Permit Review Sheet

Req by South Central Bell to construct conduit crossing over Citrus lakefront levee vic LS 289

Req by South Central Bell to Constr Conduit Crossing
over Citrus Lakefront Levee, Vic of LS 289+00, in Orleans
Parish

PROFILE HAYNE BLVD.

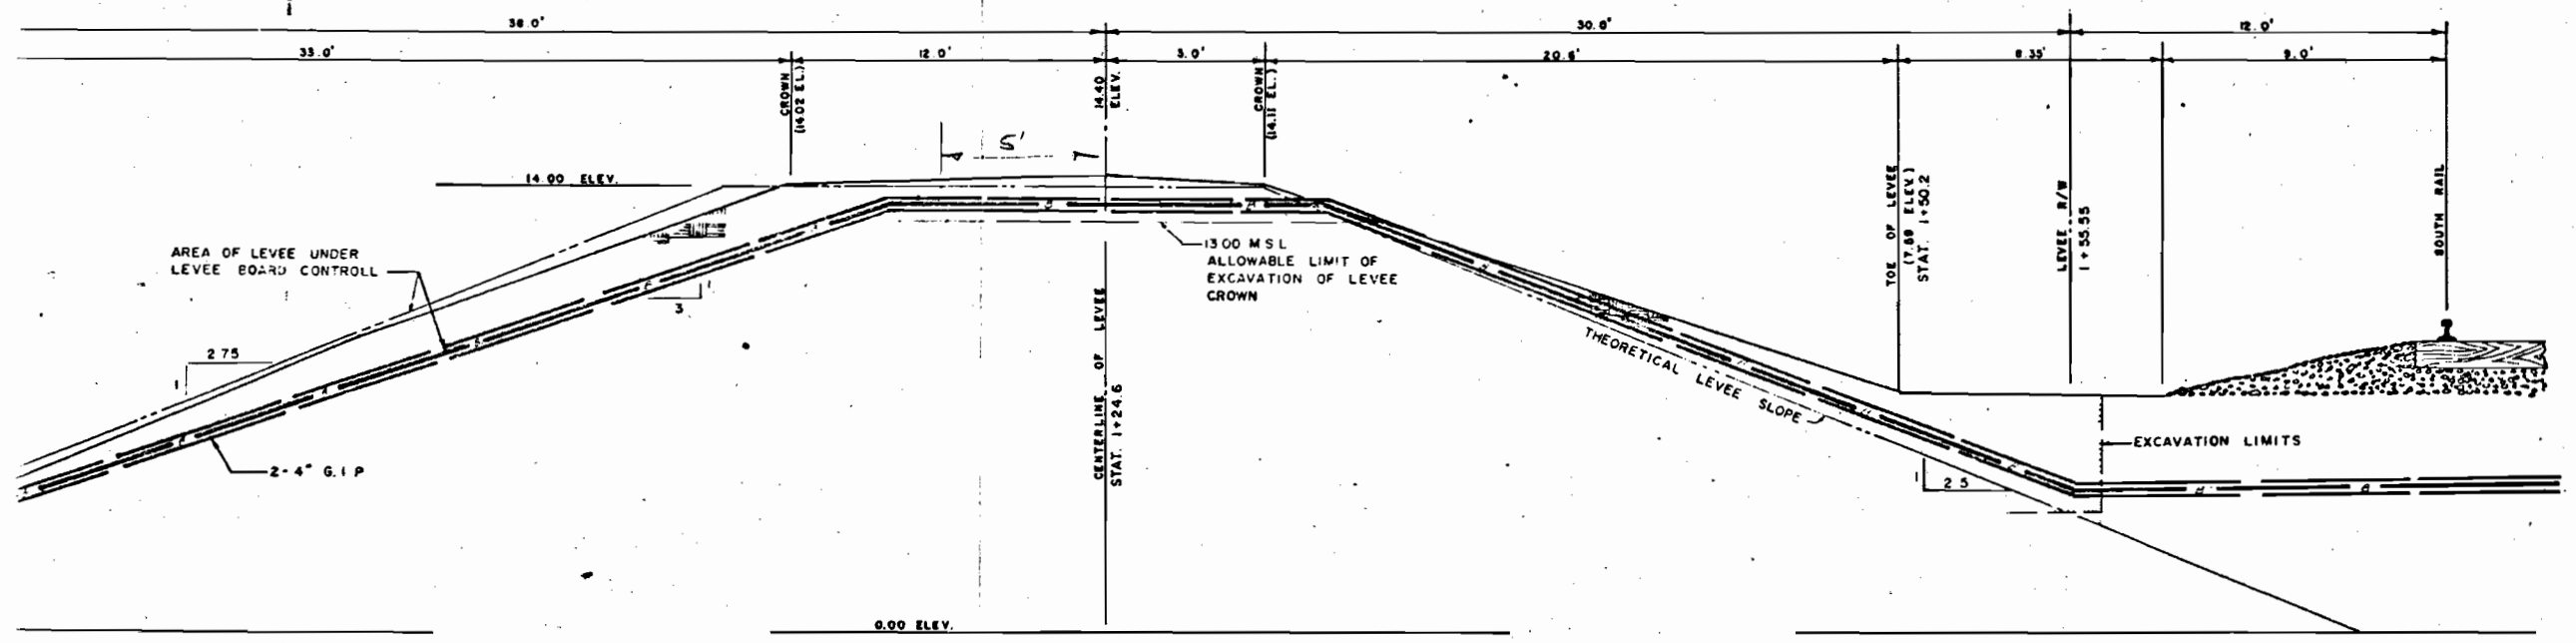
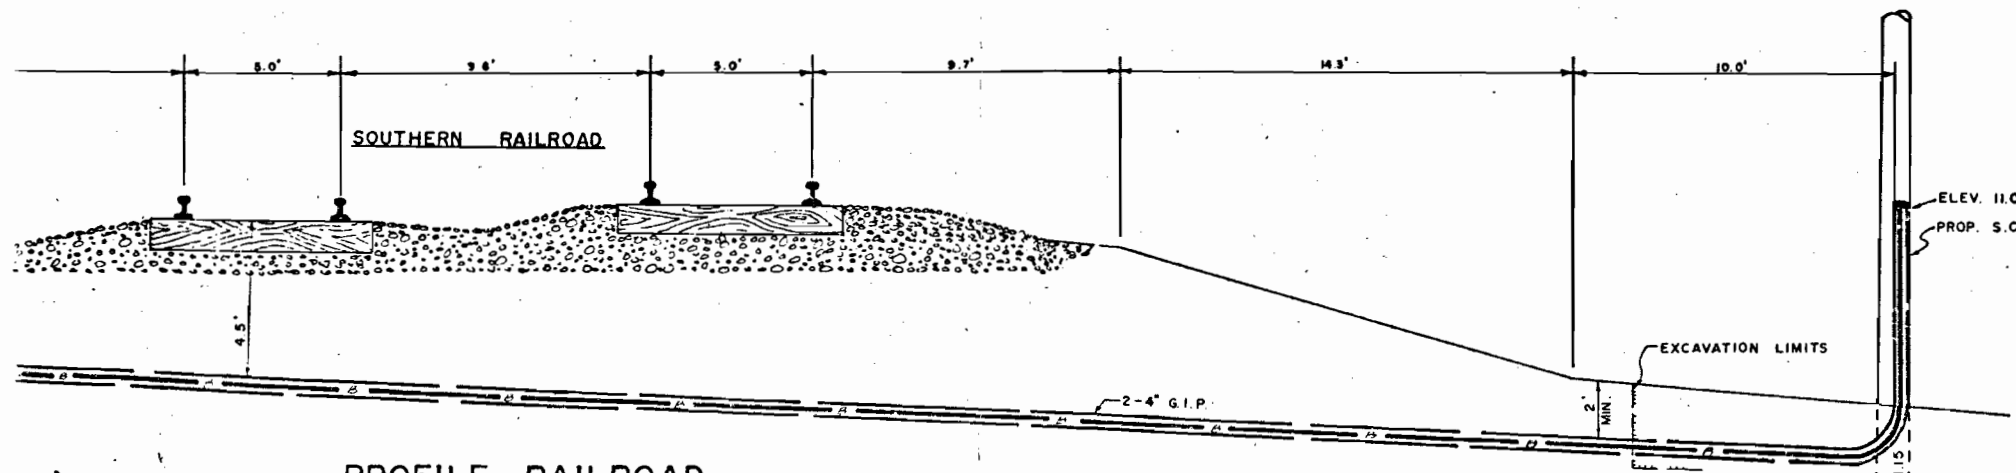
Proposed Conduit Crossing will require modification & perhaps relocating under the Lake Parkshoreline as part of Hurricane Protection project if a "High Level" plan is constructed. Permit application should be made aware of potential constraints. Dts 25 Jan 82

ED-FS No objection. Concur with ED-MP's comment above. JR 1 Feb 82
